UNITED STATES PATENT AND TRADEMARK OFFICE

| APPLICATION NO. | FILING DATE | FIRST NAMED INVENTOR | ATTORNEY DOCKET NO. | CONFIRMATION NO. |
|---|-------------|----------------------|---------------------|------------------|
| 10/716,535 | 11/20/2003 | Nicolas Roux | 245509US41X CONT | 6889 |

| Office Action Summary | Application No. 10/716,535 | Applicant(s) ROUX, NICOLAS | |

- 1) ☒ Responsive to communication(s) filed on 23 May 2006.
- 2a) ☒ This action is **FINAL**. 2b) ☐ This action is non-final.
- 3) ☐ Since this application is in condition for allowance except for formal matters, prosecution as to the merits is closed in accordance with the practice under *Ex parte Quayle*, 1935 C.D. 11, 453 O.G. 213.

FIG. 4.

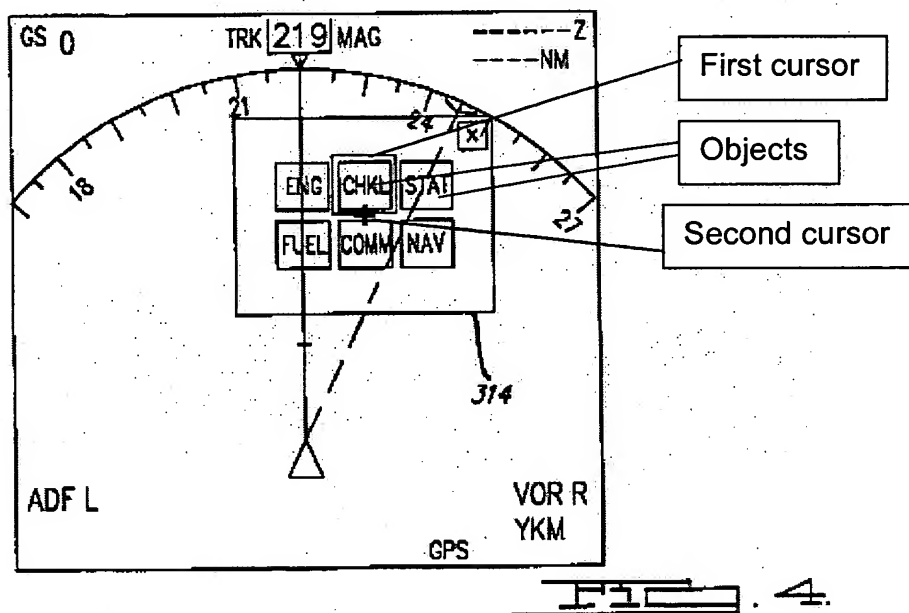
23. Applicant argues with respect to claims 1 and 12 recited “an auxiliary cursor discretely in the display from one responsive object to another responsive object” see remarks at pages 12 and 13. In response, the examiner respectfully disagrees. As stated *infra* with respect to claims 1 and 12, the examiner finds that Clark discloses “pressing a switch, 212a₁, 212a₂ or 212a₃, once would jump the cursor on display in the direction indicated. Holding the switch depressed would jump the cursor from display to display in the direction shown” see col. 6, lines 26-30. Accordingly, the feature “jump the cursor” corresponds to “moving cursor discretely” as claimed. As indicated the figure 4ⁱ given below, a first cursor corresponds to an auxiliary cursor, which moves discretely from one responsive object to another responsive object as recited claims 1 and 12 (see col. 5, lines 29-50 for further details of the explanation).
